**Supplemental Comments on U.S. Environmental Protection  
Agency Region 6 Proposed Remedial Action Plan for the  
San Jacinto Waste Pits Superfund Site  
Considering Hurricane Harvey**

Michael R. Palermo, PhD, PE  
Mike Palermo Consulting, Inc.  
10030 Green Level Church Rd, Ste 802-1280  
Cary, NC 27519-8168

October 6, 2017

Figure 1. Photos of localized displacement of armor stones following Hurricane Harvey event.

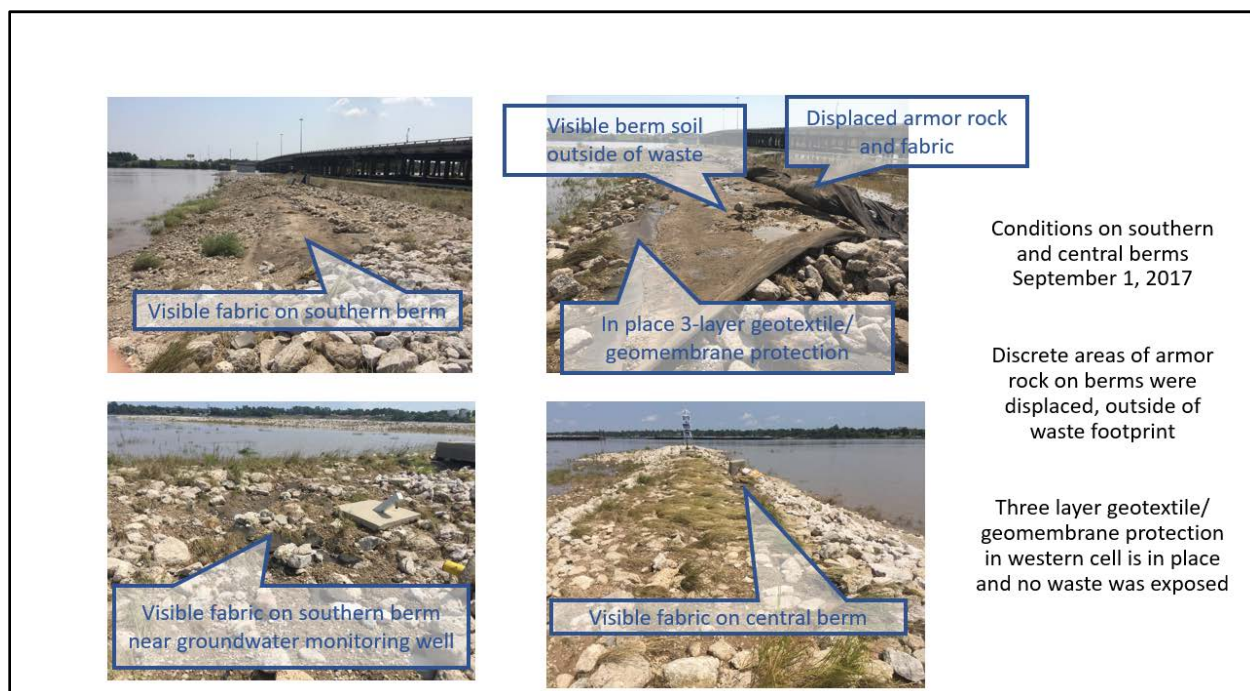
**The TCRA cap withstood the forces of Harvey, with only small areas of TCRA armor affected. These areas, as with previous maintenance activities, were largely on the raised berms in the upland portion of the Site, which do not overlie any waste material. It should be emphasized that the armor in place when Hurricane Harvey occurred was the TCRA cap designed to withstand a 100-year flood with stone sizes of 3 to 10 inches in mean diameter. Yet, the TCRA cap remained intact and effective in the face of the more extreme Hurricane Harvey event.**

Figure 1 is a collage of photos showing areas of the TCRA cap where armor stone movement occurred as a result of the Hurricane Harvey event. These photos, taken on the Western Cell, show armor stones were moved, primarily in limited areas on the raised geometry of the perimeter berm surrounding the Western Cell. The photos also clearly show that the underlying 3-layer geotextile/geomembrane that covers the waste within the Western Cell remained intact in these areas even in instances in which the surface geotextile was exposed or moved. A key result of the post-Hurricane Harvey surveys is that areas of armor stone movement were very limited in extent.

The minor movements of stone on the TCRA cap on the Western Cell were predominantly along the perimeter berm that formed a raised geometry encouraging localized higher flow velocities. Consideration should be given in a final permanent cap design to eliminate the raised geometry of the perimeter berm, resulting in a more streamlined geometry for the cap.

As mentioned above, the geotextile was exposed by movement of armor stones in several areas along the perimeter berm on the Western Cell. The crest of the perimeter berm is several feet higher than the interior of the TCRA Site. If the entire new cap surface for the Western Cell was at uniform elevation, the Site would become more streamlined, and areas resulting in localized higher flow velocities would be eliminated.

Figure 2. Post-Dive Survey Inspection Areas of Interest (AOI) (from Anchor QEA 2017a).

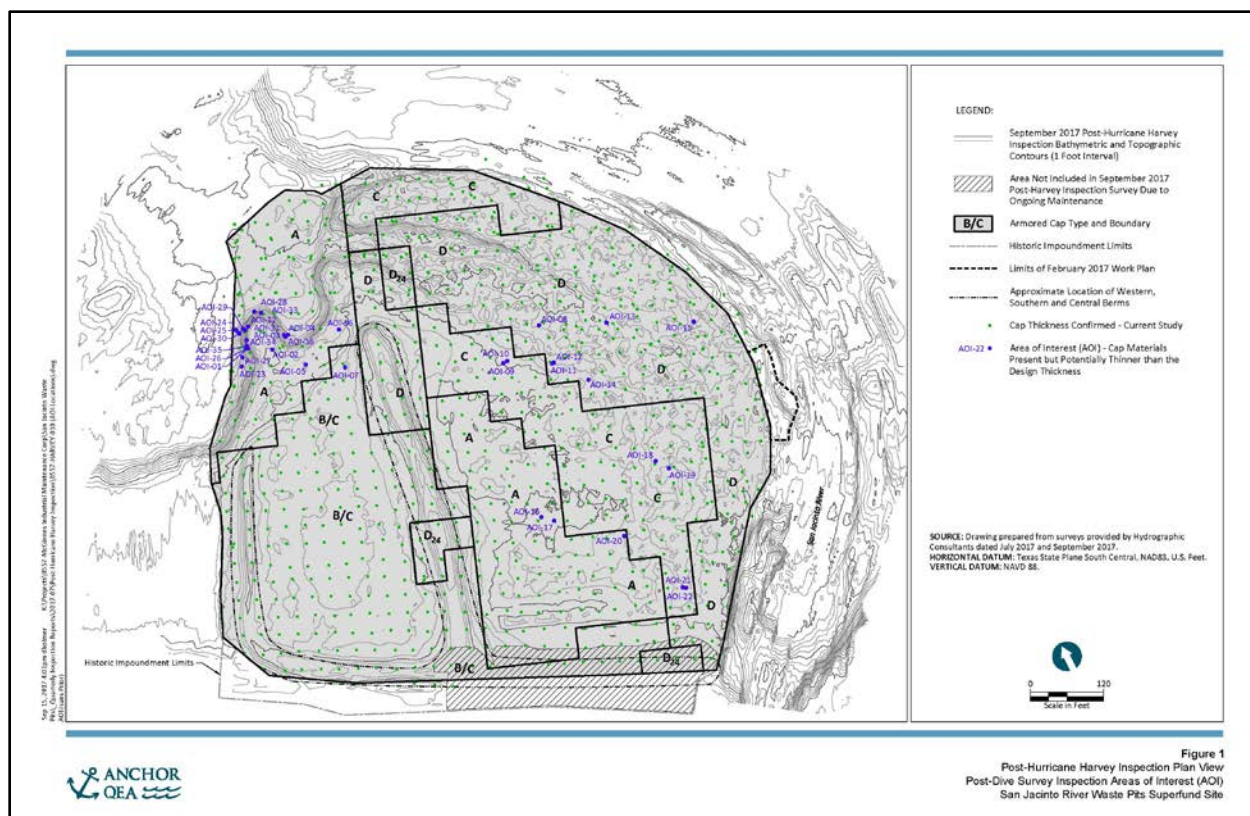
Figure 2 is a map showing the results of the visual and probing surveys taken by Anchor QEA post-Hurricane Harvey to determine cap armor stone thickness. The green dots show stations where the design cap thickness was confirmed. The map of the TCRA cap area is practically all green. The “areas of interest” are shown as blue dots and are labeled. The blue dots are widely scattered specks over the TCRA cap area, but there is a concentration of areas of interest on the northwestern perimeter of the cap. All these areas of interest were found to have armor stone still in place, but at thickness potentially less than the design thickness. The combined surface area of all the areas of interest was approximately 195 square feet, or less than 0.03 percent of the surface area of the TCRA cap. There was no evidence of a release of waste from any of these areas. (Anchor QEA 2017a). Within days following the Hurricane Harvey event, maintenance was performed in all areas of interest with armor stone thickness that could not be confirmed to be at the design thickness, using 10-inch mean diameter stone.

These survey results are indicative of the margin of safety in the design process for cap armor. The TCRA cap armor, intended as a temporary measure, was designed to protect against a 100-year event, with 3 to 10-inch mean diameter stone sizes. The basis of an armor design is to select a stone size to resist stresses that would merely induce movement of the stone, not wash the stone armor layer away. Hurricane Harvey, characterized as a 500-year event, was much stronger than the 100-year design event and did in fact move armor stones in limited areas. Yet, the TCRA cap remained intact, providing stability against the forces generated by Hurricane Harvey.

Figure 3. EPA Dive Team Sediment Samples Locations.

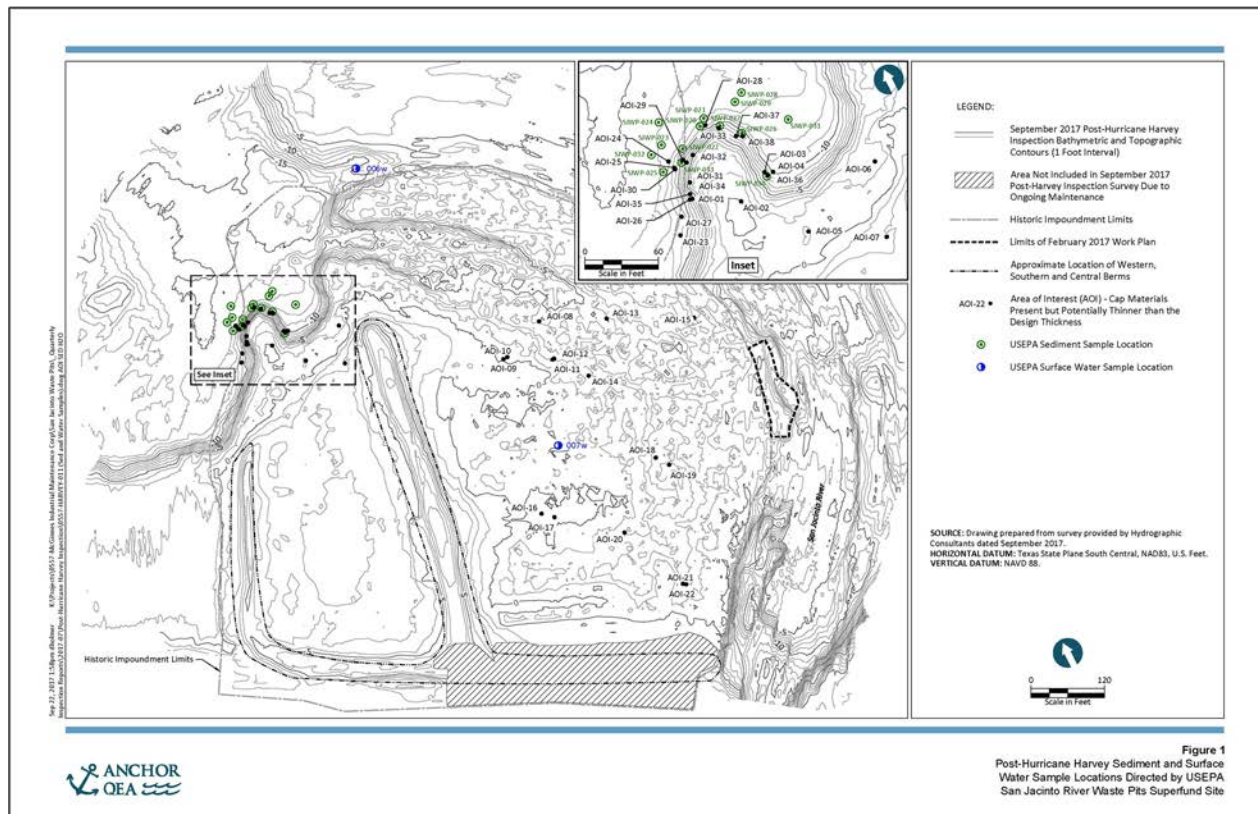
Based on the results of the probing surveys, the EPA dive team sampled the sediments accumulated on the cap surrounding and downslope from the concentration of the areas of interest with cap armor that could not be confirmed to be at design thickness. Locations of the EPA dive team samples are shown in Figure 3. These locations were selected based on “areas of interest” identified by the probing surveys described above. These samples were analyzed for toxicity equivalent quotient constituents. Of all samples taken, only one sample (at location AOI-30) had concentrations above the 200 ng/kg benchmark. Based on the data that we have now, the one sampling point with a hit is small and localized, with no other exceedances in surrounding areas. These results do not indicate any breach or release from beneath the armored cap. The EPA sampling results demonstrate that the TCRA cap was effective in containing the waste in addition to providing physical stability.

The Alternative 3aN cap would be placed over and above the existing TCRA cap. This additional large stone size armor layer would add to the integrity and effectiveness of the existing TCRA cap with respect to containment of the waste. With 15-inch mean diameter stone in place, all the submerged surface area of the cap would be subject to natural sedimentation of fine-grained material. This accumulation of clean sediment would fill in interstices of the 15-inch mean diameter armor stone layer, thereby providing additional containment capacity.

Figure 4. Map showing elevation changes at the TCRA Site resulting from Hurricane Harvey (from Anchor QEA 2017b).

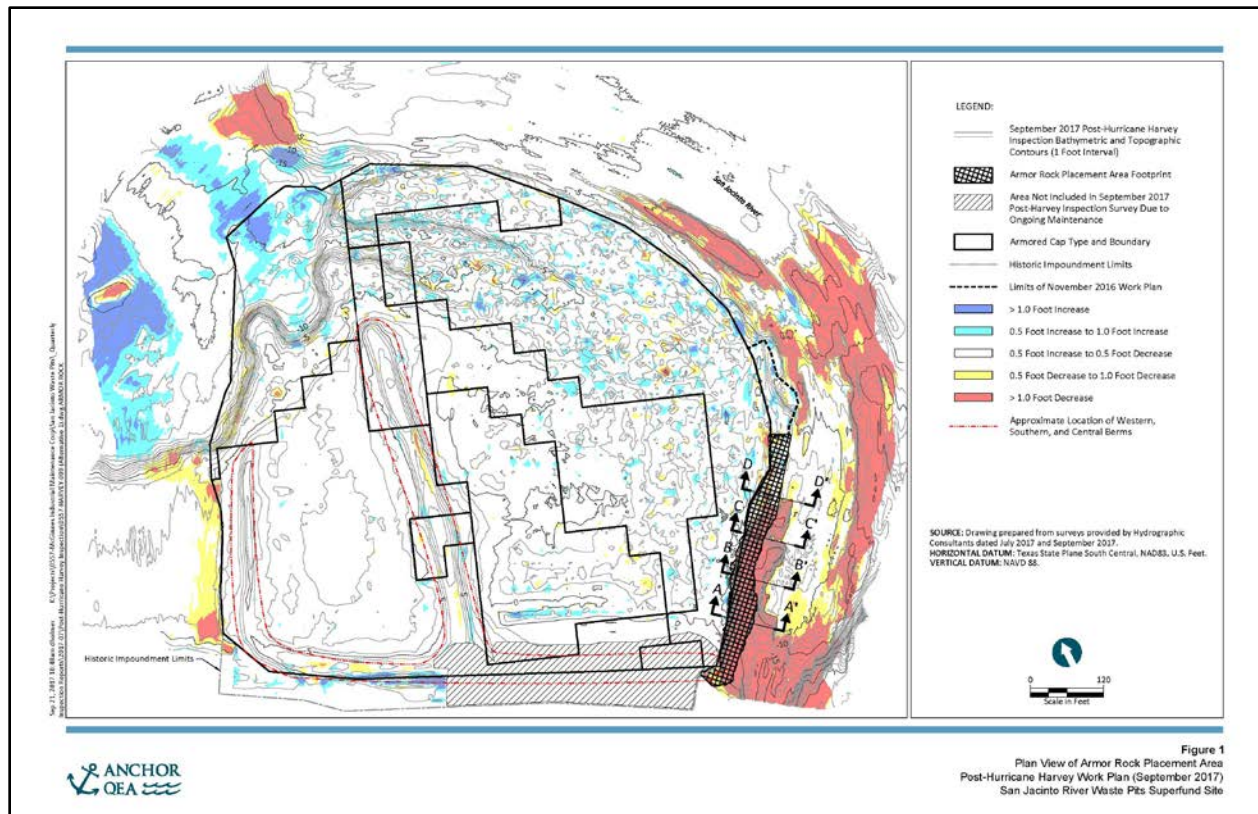
Anchor QEA conducted a topographic and bathymetric survey of the Site and surrounding area and compared the results with pre-Hurricane Harvey results. Results of these surveys are mapped in Figure 4. The blue and white shading indicates areas with increases in surface elevation or no change in elevation. The yellow and orange shading indicates areas with reductions in elevation, indicative of scour due to Hurricane Harvey. With the exception of very small areas, the entire surface of the TCRA cap shows no decrease in elevation, demonstrating that the TCRA cap remained stable.

Areas outside of and around the periphery of the TCRA cap are not armored. The cross sections accompanying the map show areas immediately adjacent to the TCRA cap with significant elevation decreases indicating scour had occurred. Areas of particular concern include the area immediately adjacent to the eastern edge of the TCRA cap and the area at the prominent feature at the northwest edge of the cap (this is the same area with multiple small “areas of interest” with reduced cap thickness that the EPA dive team focused its sediment sampling effort).

This observed scouring does not indicate a potential issue with the stability of either the TCRA cap itself or of the Alternative 3aN enhanced cap. The caps themselves are armored. But clearly, these results in non-armored areas indicate the need to address the areas adjacent to the cap boundary to avoid potential undermining of the armored cap. Such an enhancement of the Alternative 3aN enhanced cap was mentioned in both the USACE report and in my earlier comments on the PRAP. This can be accomplished by flattening the cap slopes to extend the armor stone protection beyond the present limits of the TCRA cap. Anchor QEA has prepared conceptual drawings showing the flattened slopes as shown in Figure 5. Additional protection could be provided by including an armor stone toe berm at the edge of the cap. These enhancements to the design of the Alternative 3aN cap would avoid potential undermining of the cap.
